Docket Number:	17-IEPR-01
Project Title:	General/Scope
TN #:	222479
Document Title:	Revision - CHBC Comments on IEPR Proposed Final Draft
Description:	N/A
Filer:	System
Organization:	Emanuel Wagner
Submitter Role:	Public
Submission Date:	2/8/2018 11:15:44 AM
Docketed Date:	2/8/2018

Revision - CHBC Comments on IEPR Proposed Final Draft

California Hydrogen Business Council

Comments on 2017 Final IEPR Report

Hydrogen as Long Duration Storage

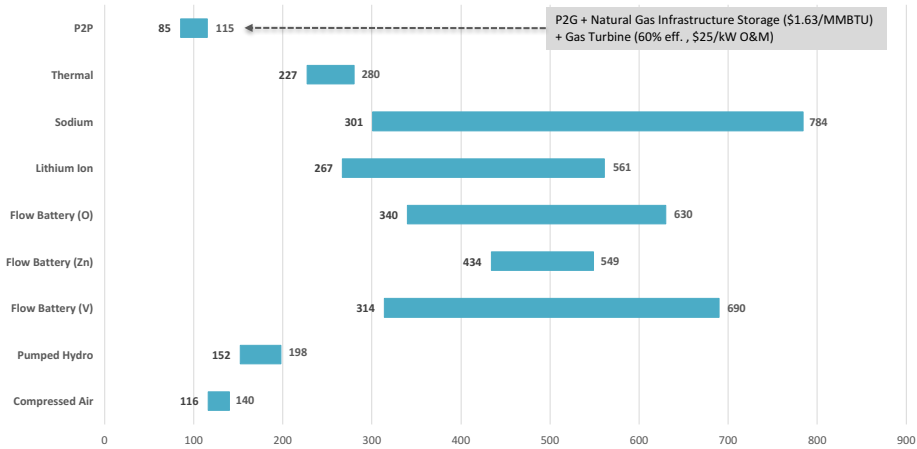
The chart below shows the potential cost competitiveness of hydrogen as energy storage compared to other carriers.
